Non-LOCA Release Fractions Feedback

Frankie Pimentel, Sr. Project Manager -
Engineering & Risk, NEI

Feedback on Non-LOCA Release Fractions - Proposed PWR Non-LOCA Power Envelope

Feedback on Non-LOCA Release Fractions - Proposed BWR Non-LOCA Power Envelope

BWR Rod Power History - Range of Applicability
(Peak Power -15.0 kW/ft BWR (10x10))

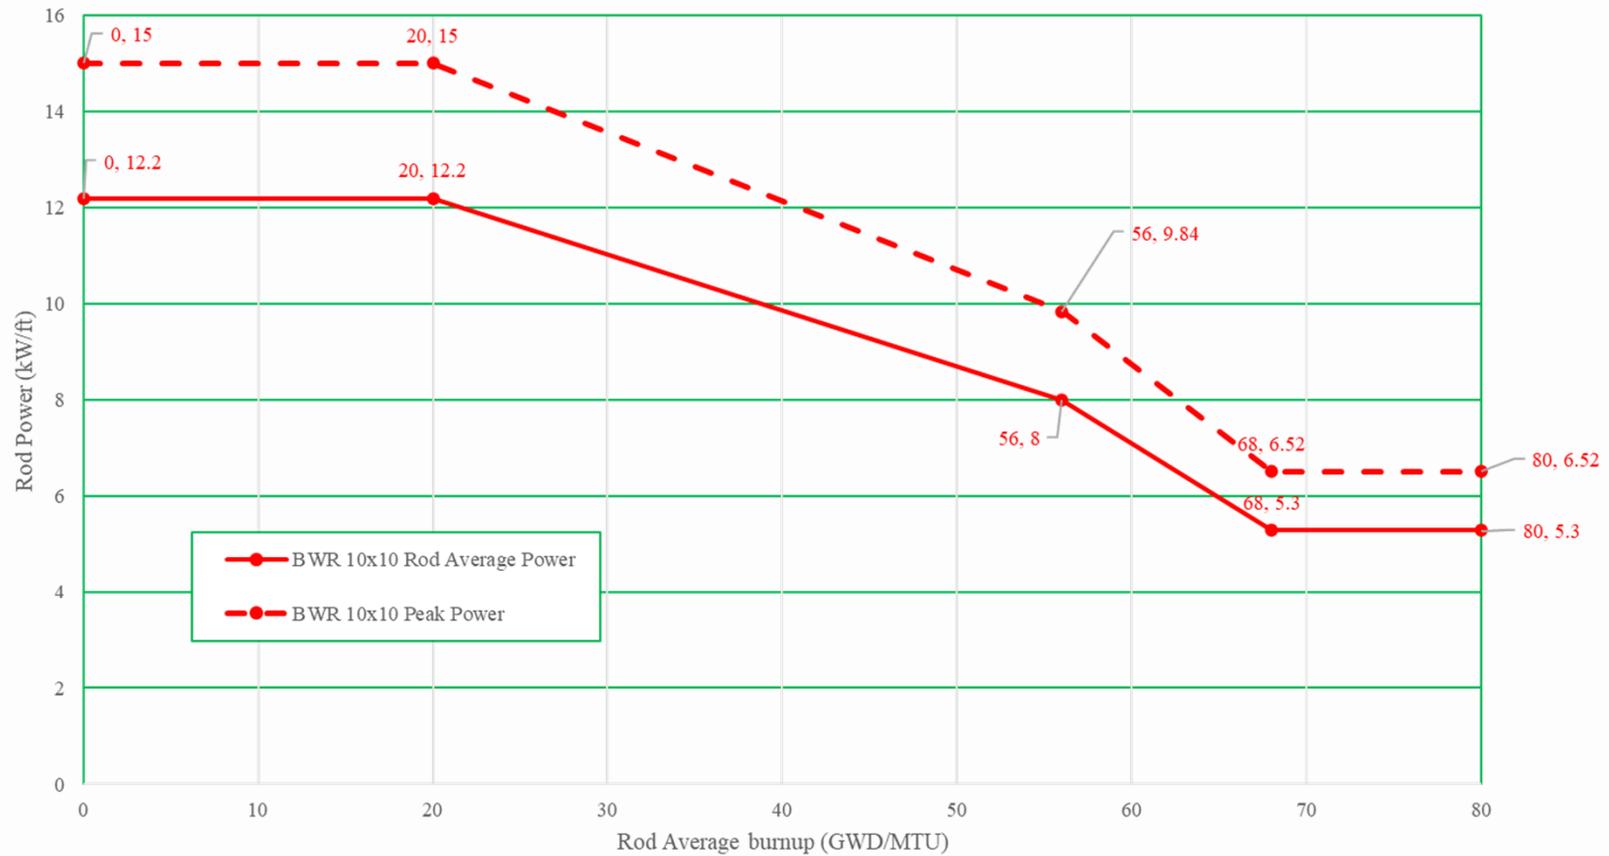
- Modify the third paragraph in Section C (page 9 RG 1.183 R1) to provide the flexibility to use Appendix I in cases where peak exposures, powers or enrichments go outside of the applicability of Figure 1
